Product Change Notice

New dice replacement for Surface Mount Display

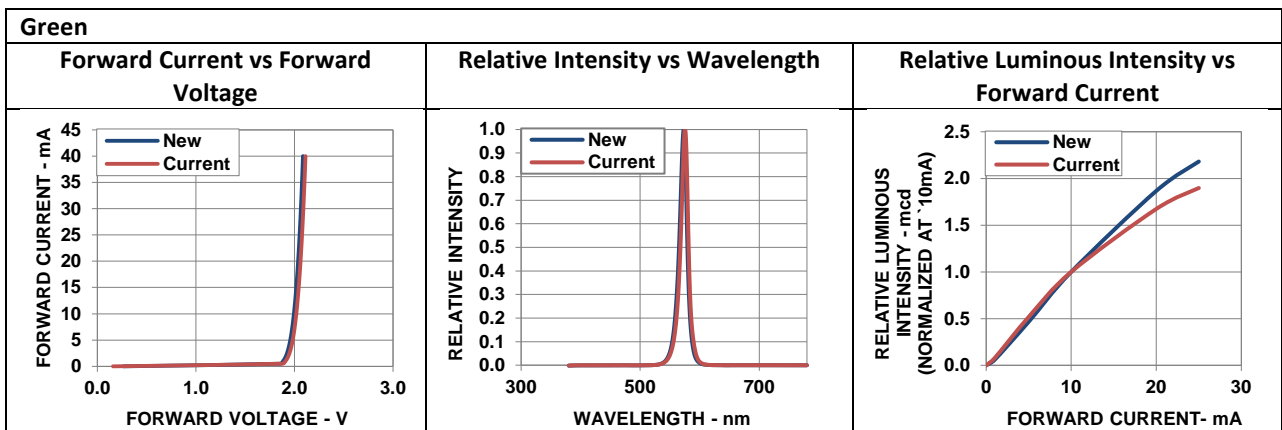
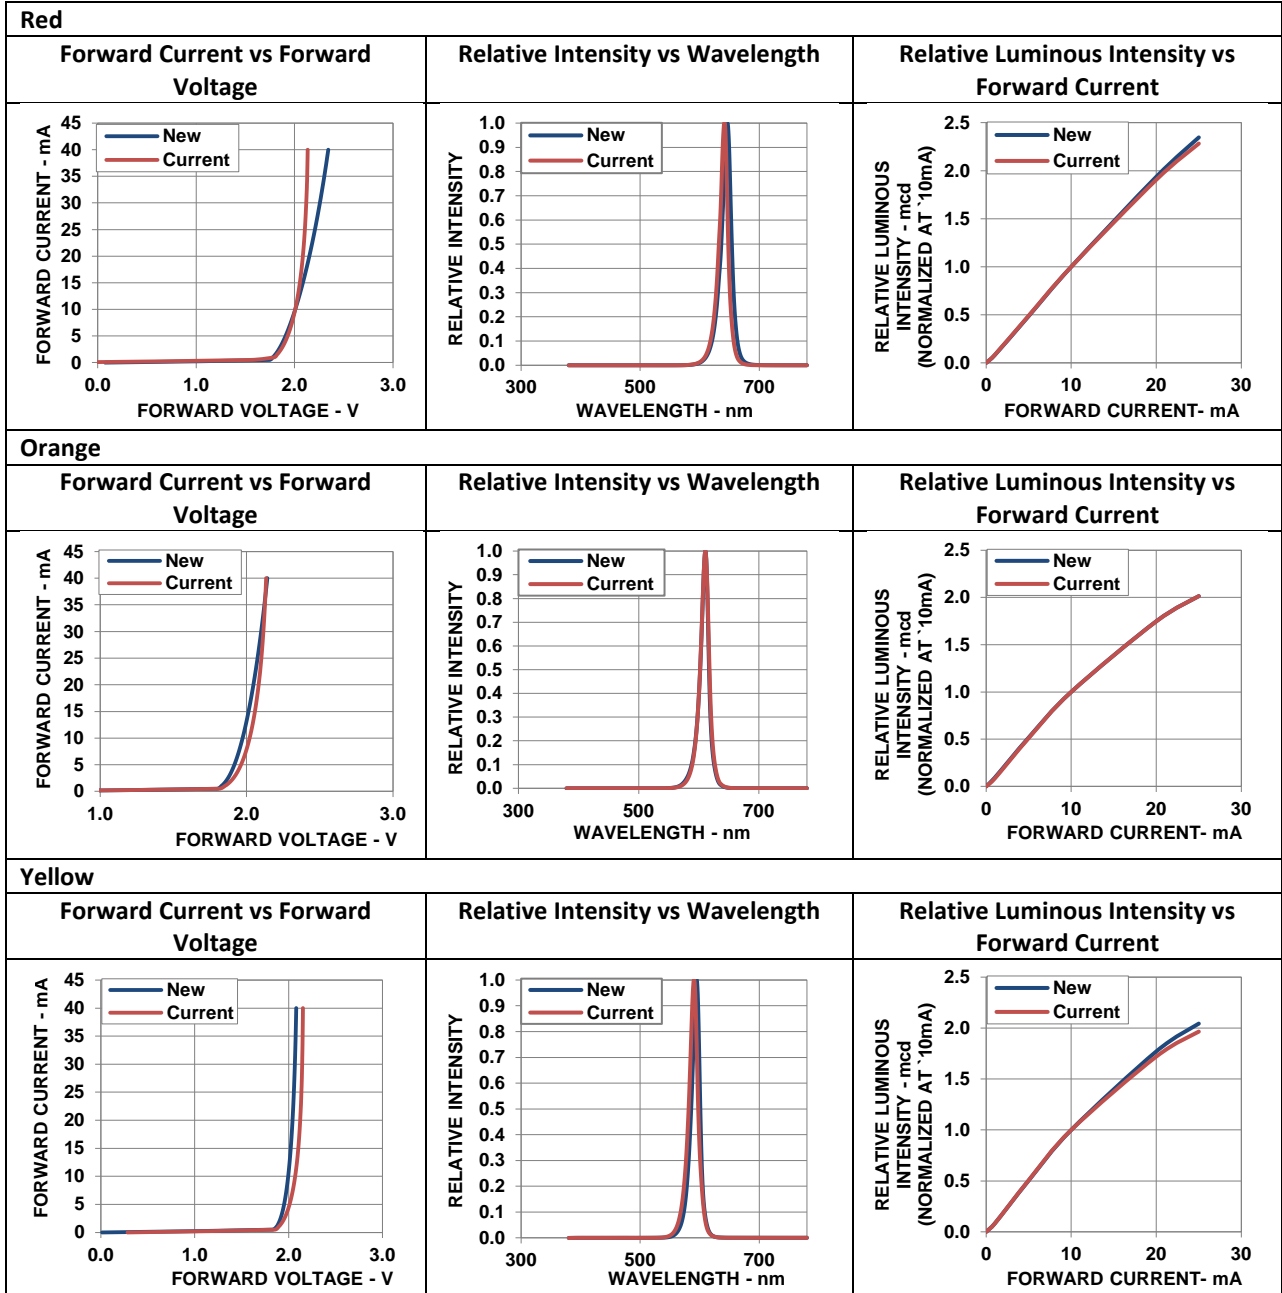
Following are changes in product characteristic:

1. Forward Voltage vs Forward Current
2. Relative Intensity vs Wavelength
3. Relative Intensity vs Forward Current

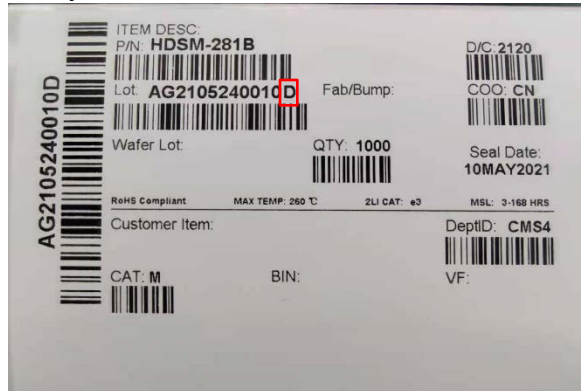
Label for current dice

Label for new dice

Prefix "D" will be added to Lot number for part after PCN Change.
